Access Compliance Report Public Rights-of-Way (Curb Ramps)

Intersection ID: 14905 Main Street: REMOUNT RD **Cross Street: YOUNGBLOOD ST** Location: ADA ID: 3DBF9486E714 Ramp Type: PerpDiag Initial Pass/Fail: Fail **Overall Compliance: No** Severity Score: 33.75

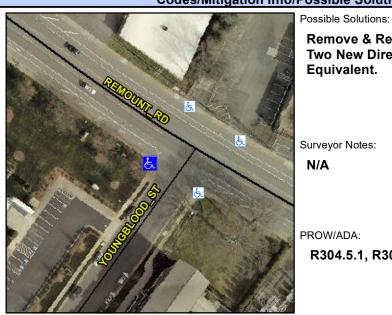
R304.5.1, R304.5.3

Compliance Description		Data	Comp	liance Description	Data
N/A	Ramp Length (in)	60.0	Yes	Ramp Slope (%)	5.7
No	Ramp Width (in)	43.0	No	Ramp XSlope (%)	7.7
N/A	Flare Type LT	N/A	N/A	Flare Type RT	N/A
N/A	Flare Slope LT (%)	N/A	N/A	Flare Slope RT (%)	N/A
N/A	Flare Traversable LT?	N/A	N/A	Flare Traversable RT?	N/A
N/A	Landing Length (in)	N/A	N/A	DWS Provided?	N/A
N/A	Landing Width (in)	N/A	N/A	DWS Contrast?	N/A
N/A	Landing Slope (%)	N/A	N/A	DWS Length (in)	N/A
N/A	Landing X Slope (%)	N/A	N/A	DWS Full Width?	N/A
N/A	Landing Curb? (Y/N)	N/A	N/A	DWS Offset (in)	N/A
N/A	Shared Landing?	N/A			
N/A	Gutter Ponding?	N/A	N/A	Gutter Slope (%)	N/A
N/A	Gutter Lip Ht (in)	N/A	N/A	Gutter X Slope (%)	N/A
N/A	Painted X Walk1?	No	N/A	Painted X Walk2?	No
	X Walk 1 Direction	To SE		X Walk 2 Direction	To NE
N/A	X Walk 1 Width (in)	N/A	N/A	X Walk 2 Width (in)	N/A
	X Walk 1 Slope (%)	4.1		X Walk 2 Slope (%)	3.0
	X Walk 1 X Slope (%)	5.9		X Walk 2 X Slope (%)	4.4

Remove & Replace Curb Ramp With **Two New Directional Ramps or** Equivalent.
